## SERVICE BULLETIN

**APPLICABILITY:** 2013-2017MY BRZ, 6MT Models

**NUMBER:** 03-77-17

**SUBJECT:** “Rotational” Sound from Clutch Release Bearing

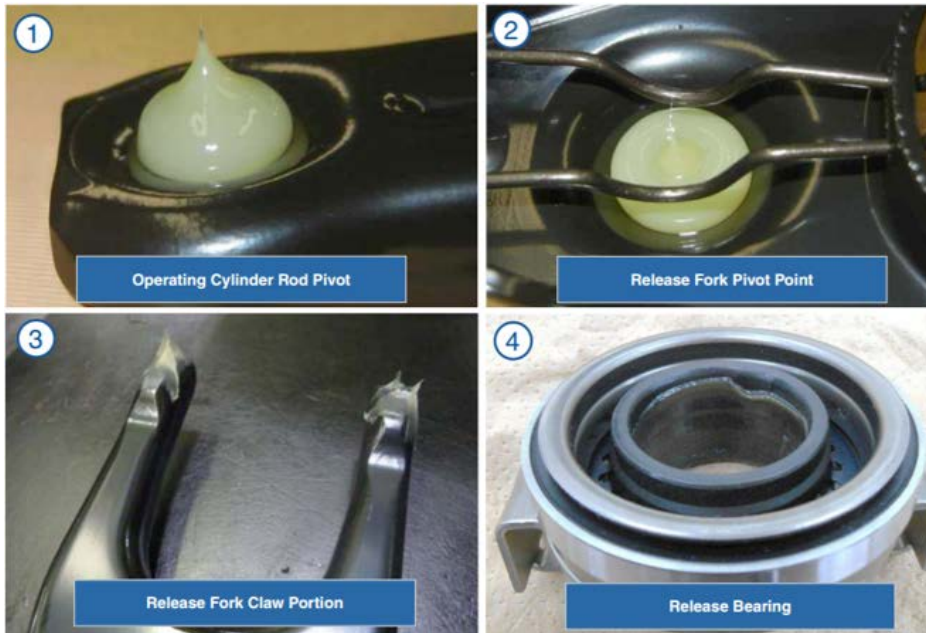
- Always inspect for any excessive or abnormal wear on the release fork pivot point, operating cylinder rod and release lever pivot points, and the pivot ball.
- Always use the proper grease (Nichimoly N-130, Conoco-Philips Multiplex Red #2 or Subaru p.n. 000041000) when lubricating the contact points of the release bearing and related components as specified in the Service Manual and shown below.

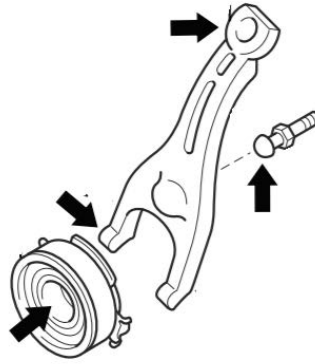
- The new clutch release bearing part number is: **30502AA150**.
- The new bearing can be identified by a white paint dot on the attachment “ear” as shown in the illustration to the right.
